AGENDA
Planning and Zoning Commission
September 16, 2026 – REGULAR MEETING
5:30 PM

MINUTES
PLANNING AND ZONING COMMISSION
TOWN OF JACKSON, WYOMING
September 2, 2026
UNAPPROVED

Meeting Date:	September 16, 2026	Meeting Title:	Planning Commission
Submitting Department:	Planning Department	Presenter:	Katelyn Page
Agenda Item:	Development Plan for a new 3-story mixed-use building at the properties addressed 655 and 665 South Cache Street (P26-058)	Public Comment:	Yes

PARKING GARAGE OVERVIEW - C3.1

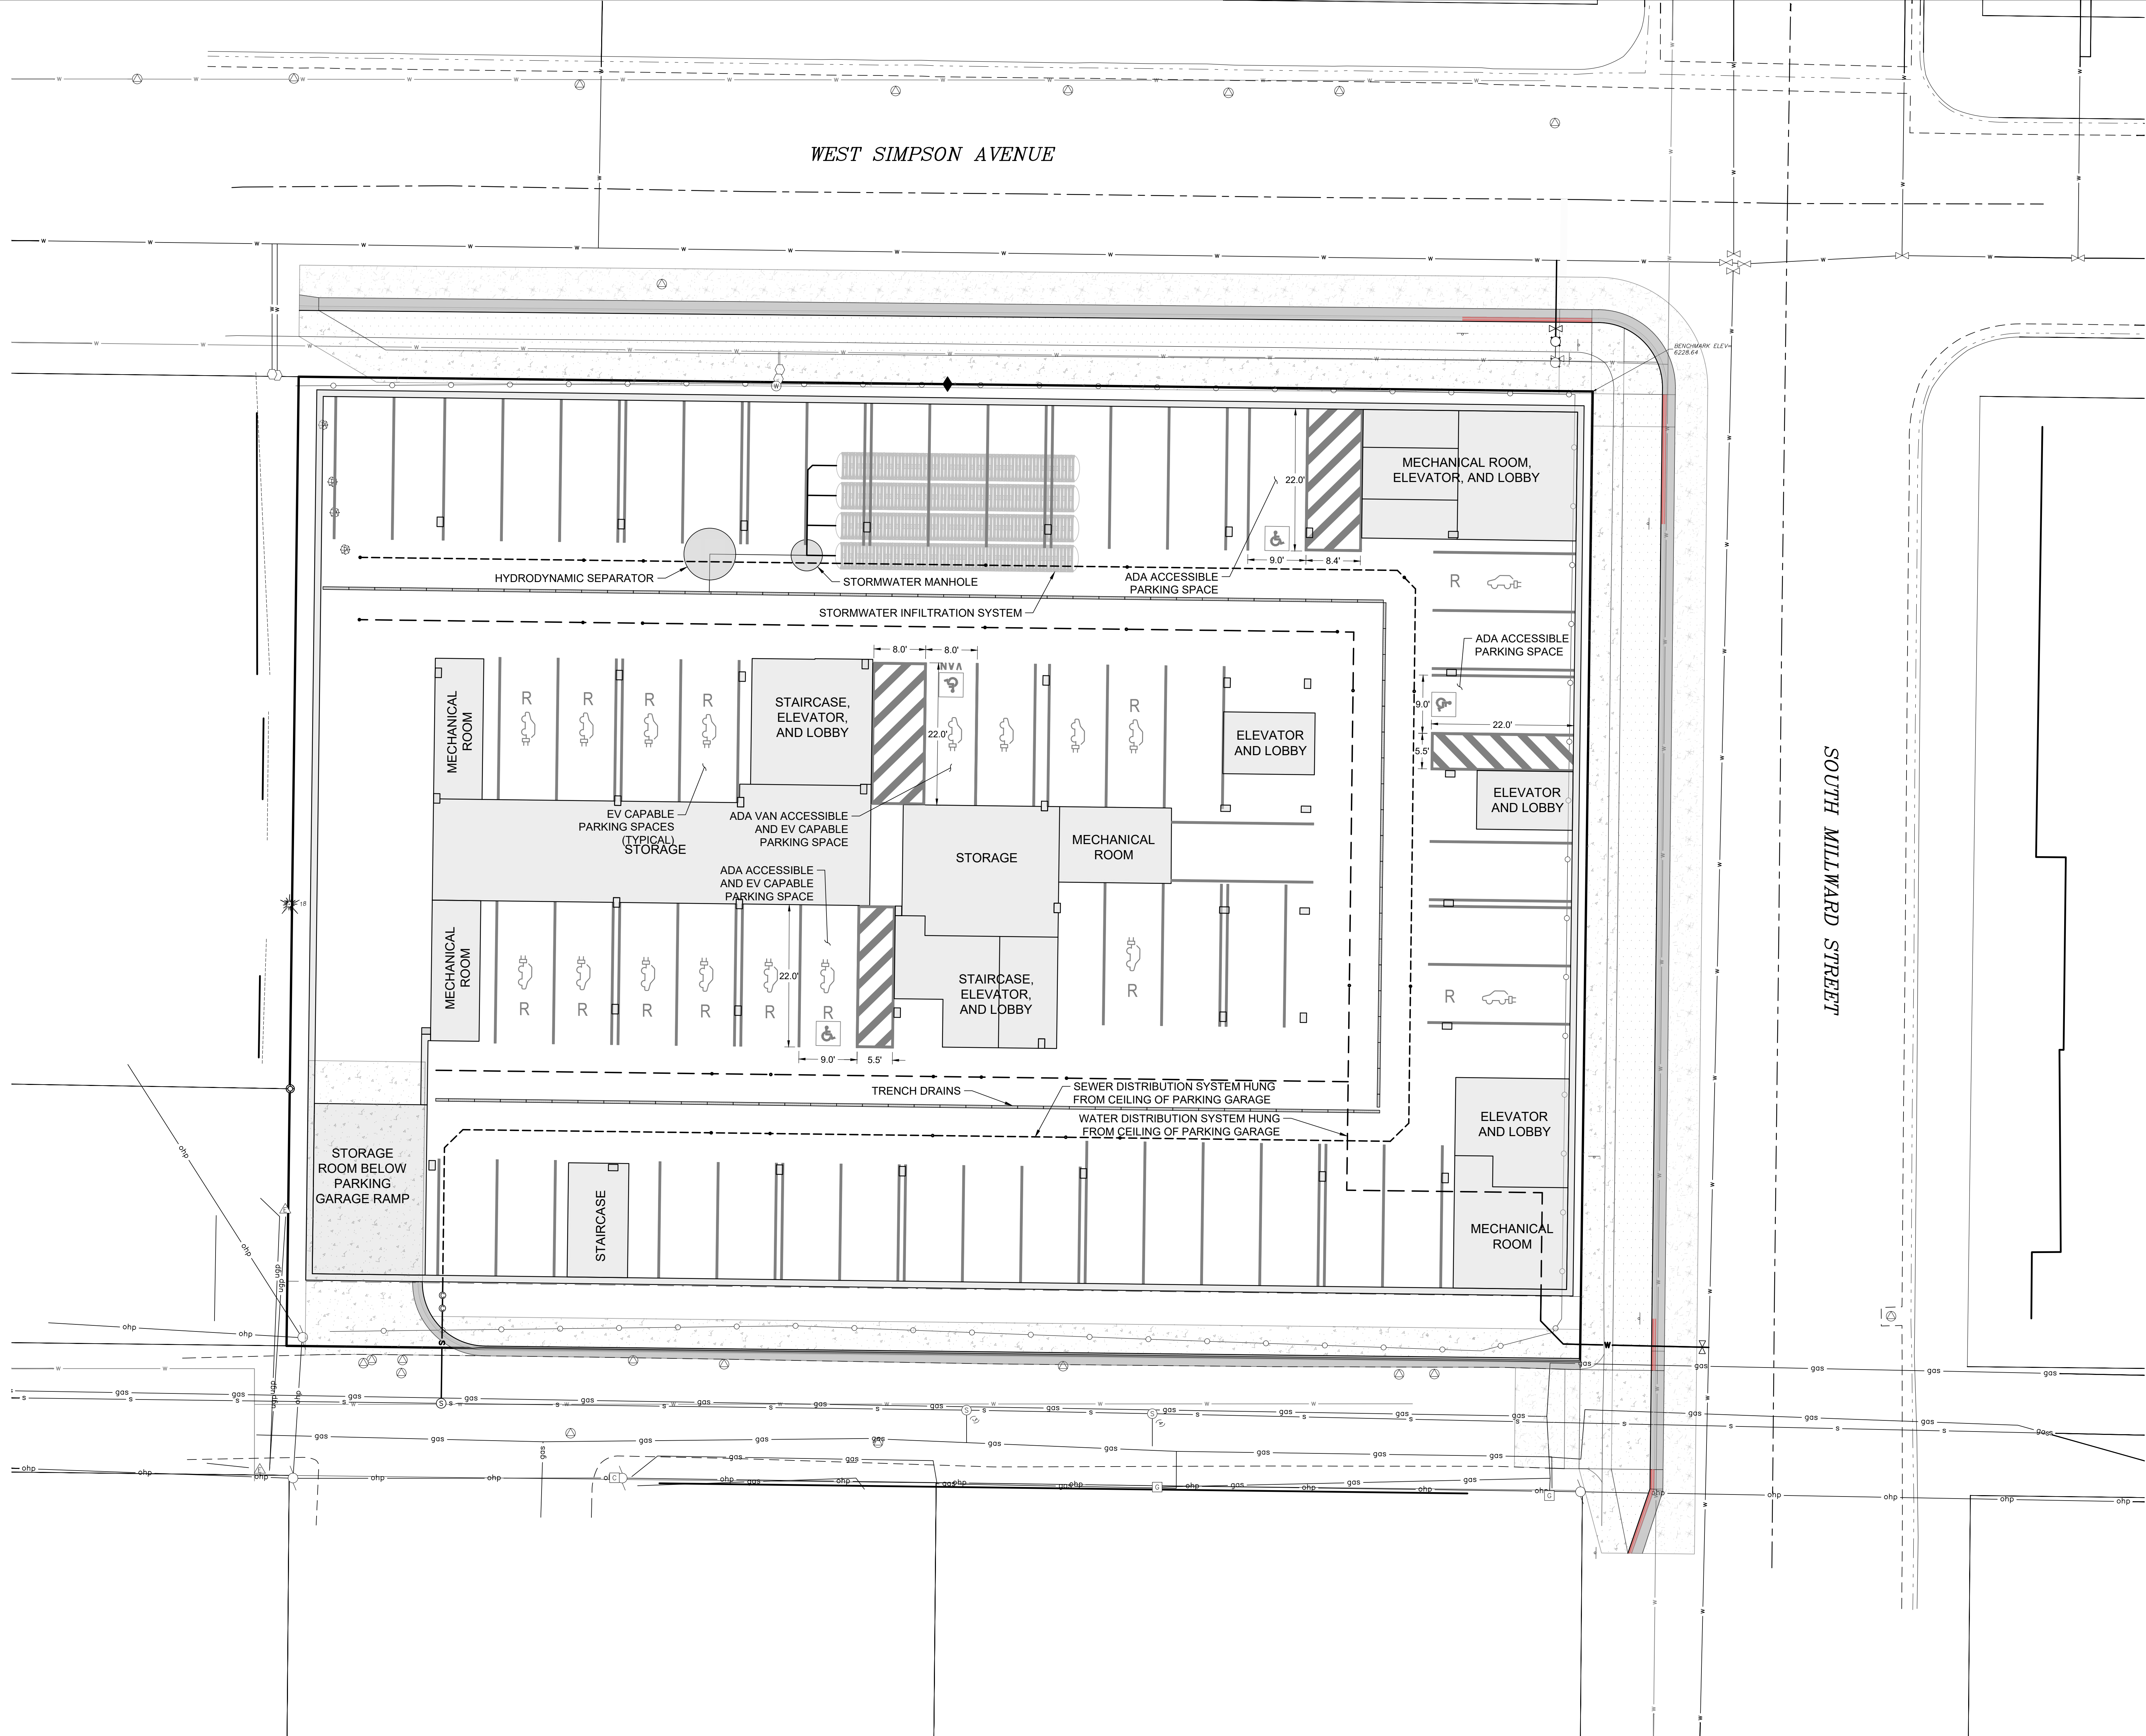
9. C3.1: Provide documentation that the proposed separator unit can be serviced inside the parking garage, i.e. provide the maintenance requirements, the equipment required to maintain, and sufficient information to document that the equipment can access and service the separator. Provide details on how the system can be maintained and replaced over time.

10. C3.1: Review the ADA parking space requirements and provide the appropriate number of van and standard accessible parking spaces. Revise as necessary.

RIGHT-OF-WAY GRADING OVERVIEW - C4.0

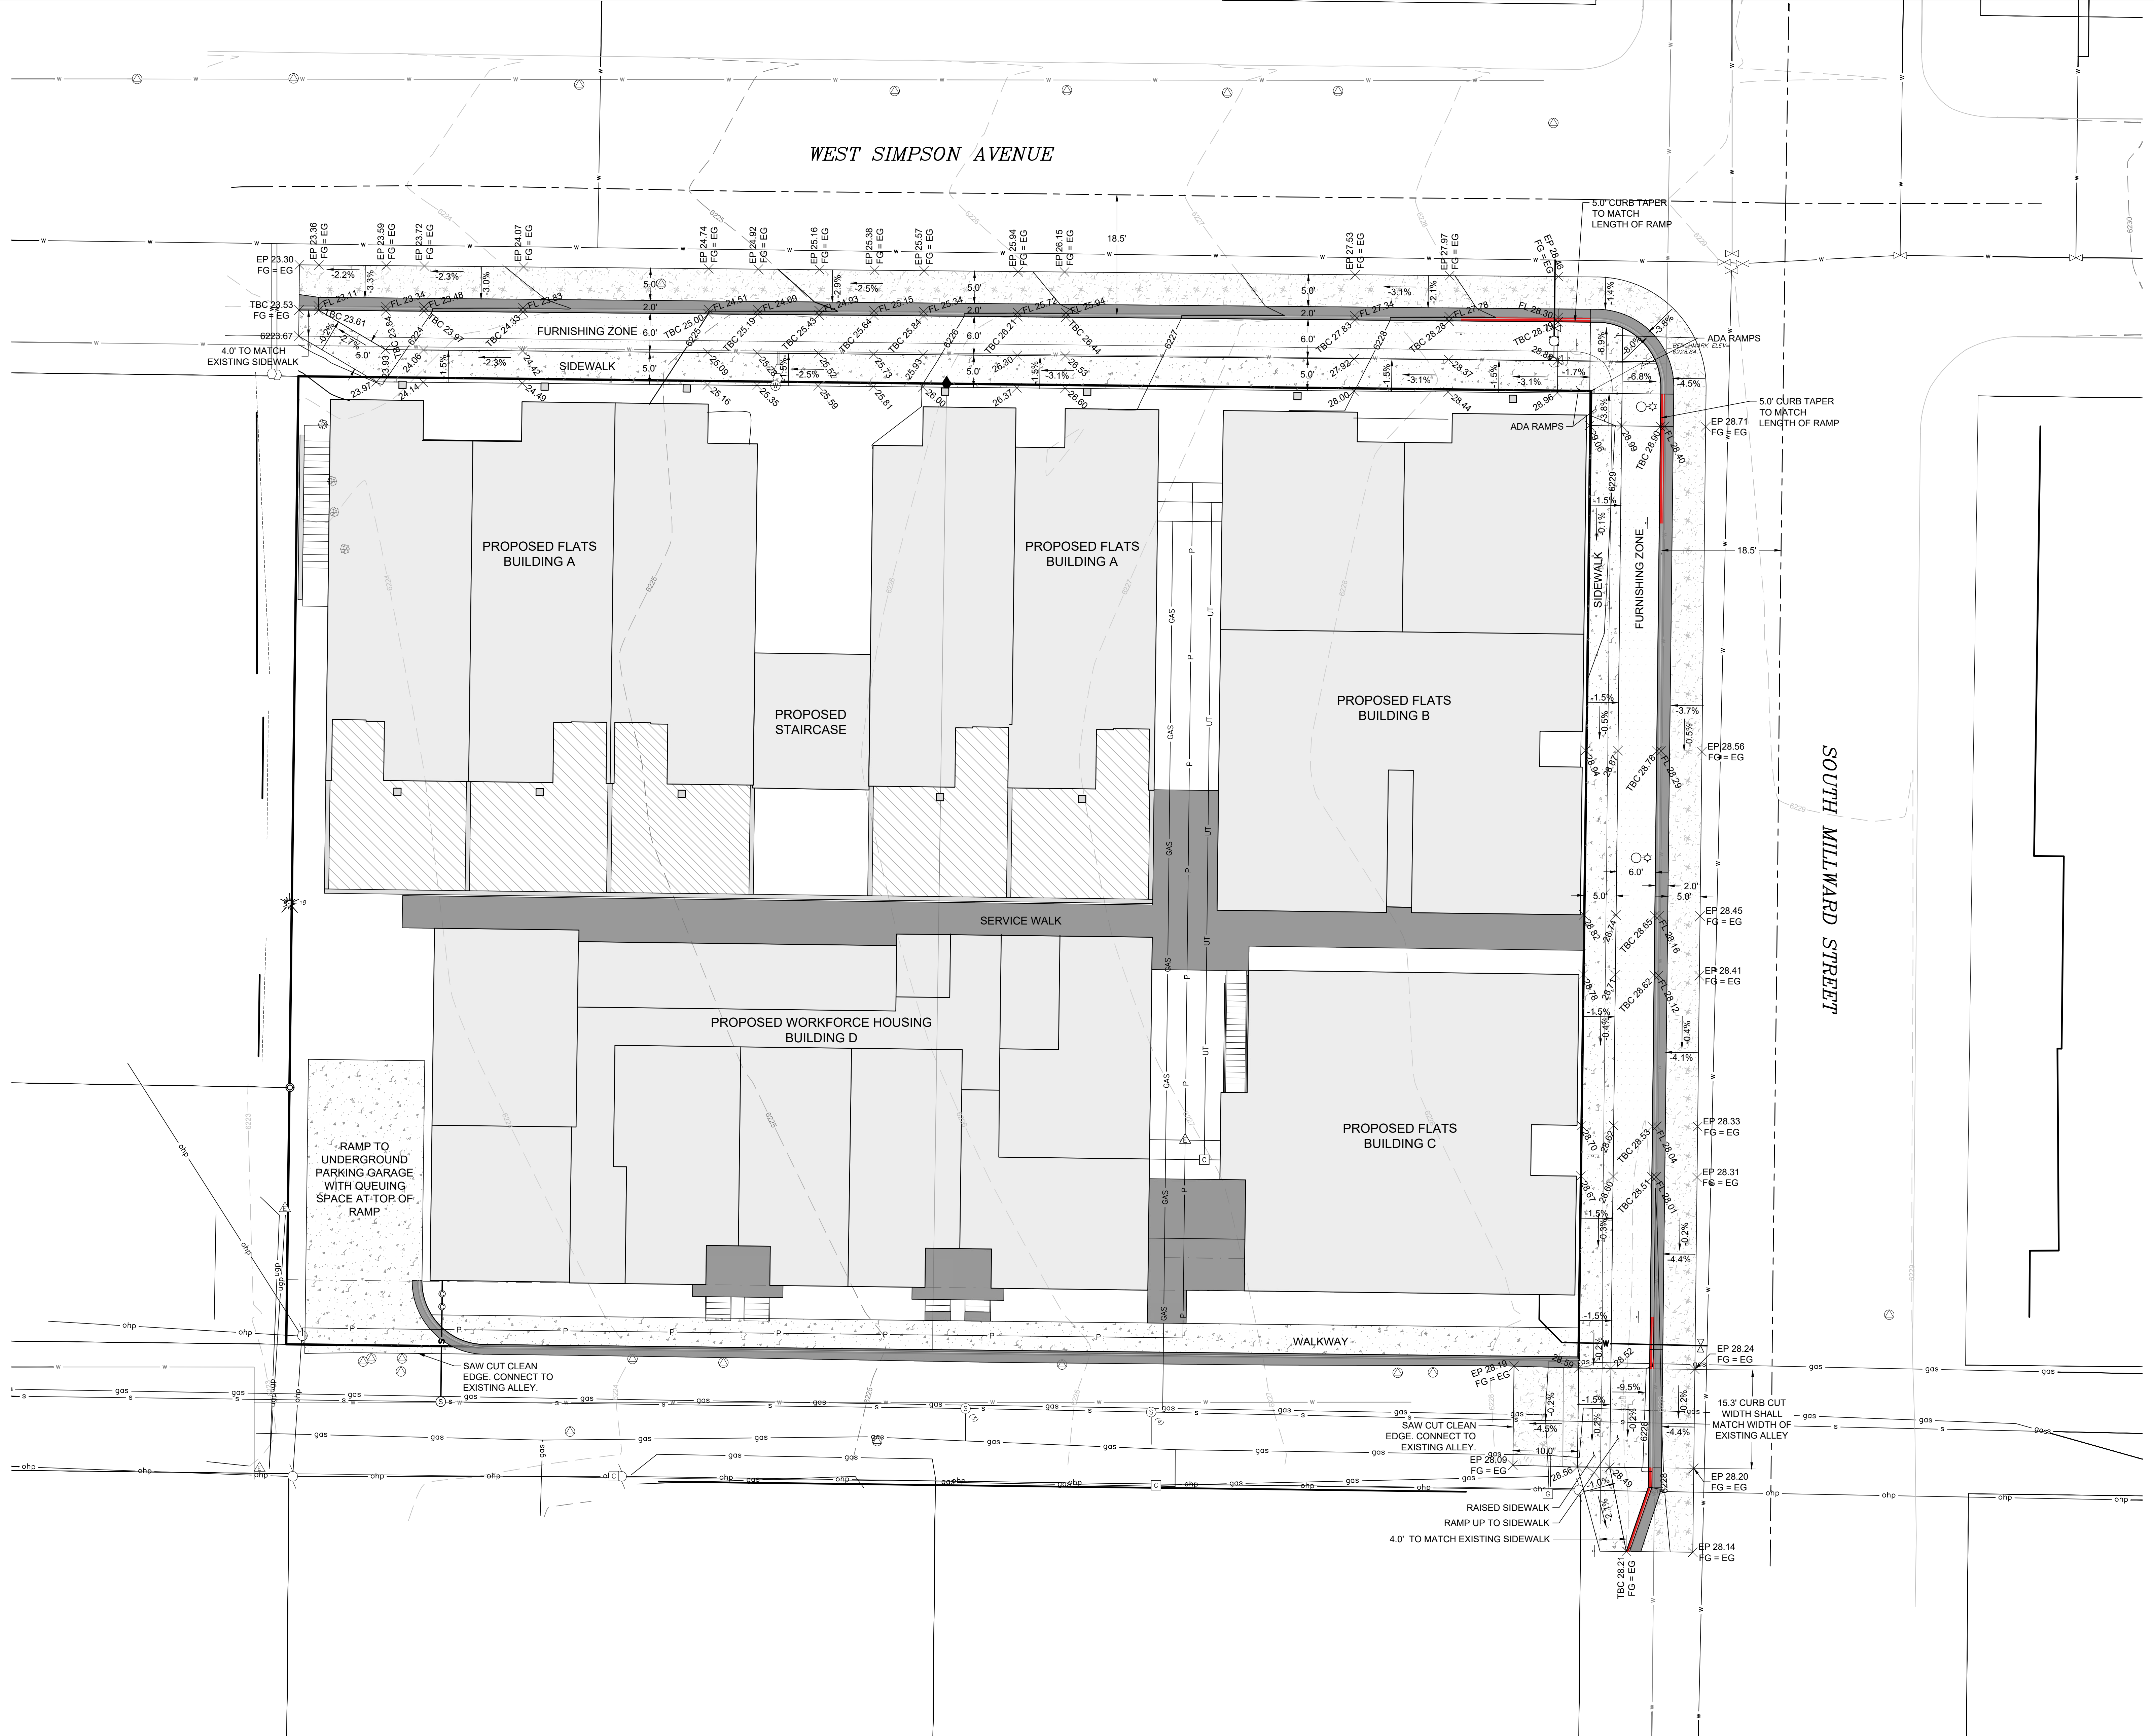
11. C4.0: The asphalt patch on S Millward Street exceeds ToJ standard maximum slope of 4%. Provide cross-sections and a profile showing the existing asphalt at lip of curb, flow line, top back of curb, front and back of sidewalk. The patch may need to be extended to reduce the cross-slope to less than 4%.

- C4.0: Revise the concrete garage access driveway to not encroach into the right-of-way. End the concrete at the property line/back of curb.
- C4.0: The existing alley has an asphalt surface, show the asphalt patch required to install the doghouse manhole for the sanitary sewer. The existing gas line in the alley may be in conflict with installing the doghouse manhole. Provide construction notes to verify the gas line location prior to installation.

X
CX.X MANHOLE ADJUSTMENT & COLLAR IN LANDSCAPE
NOT TO SCALE

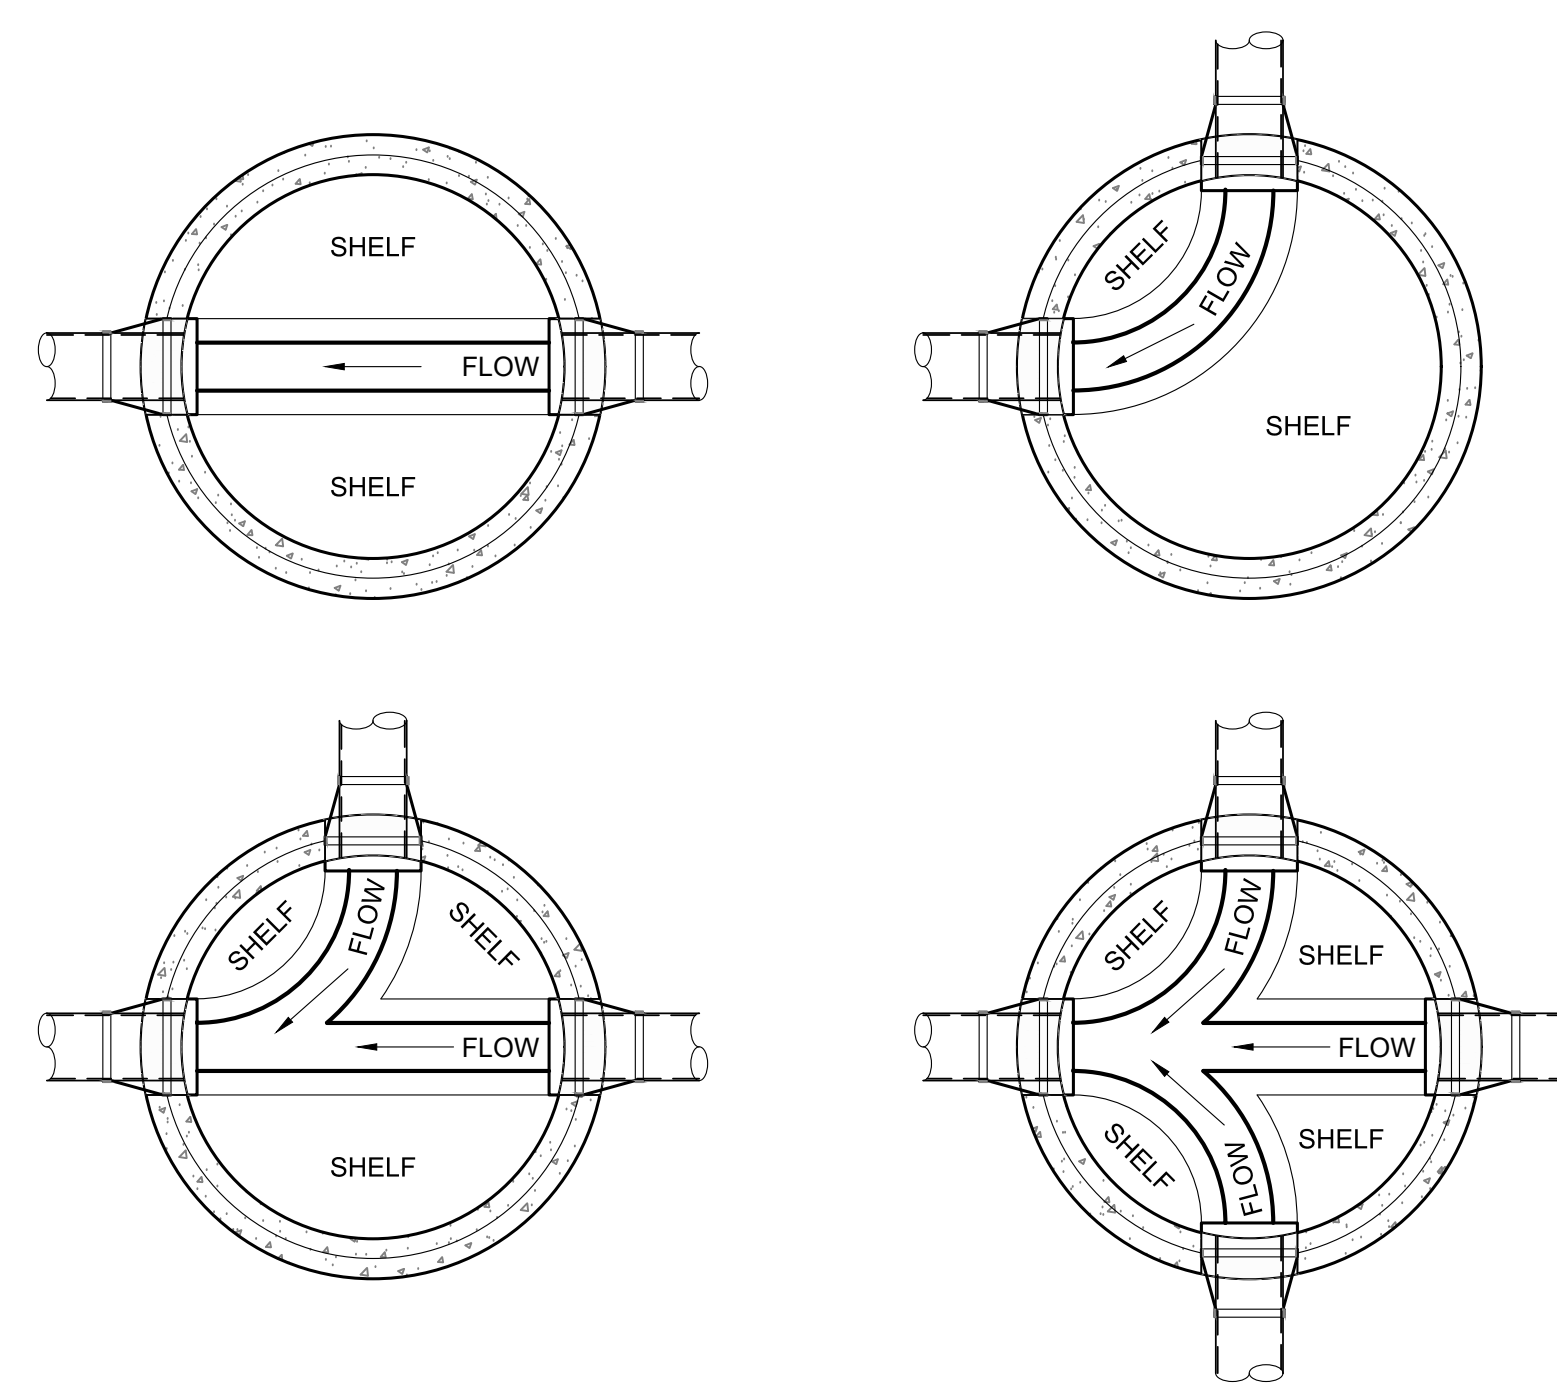
- C5.3: Delete steps on the manhole detail along with the manhole adjustment and collar in landscape detail.
- C5.3: Building cleanout detail, note 4 requires solvent cement for all PVC fittings. General Construction Notes call for gasketed PVC fittings. Delete solvent cement note.
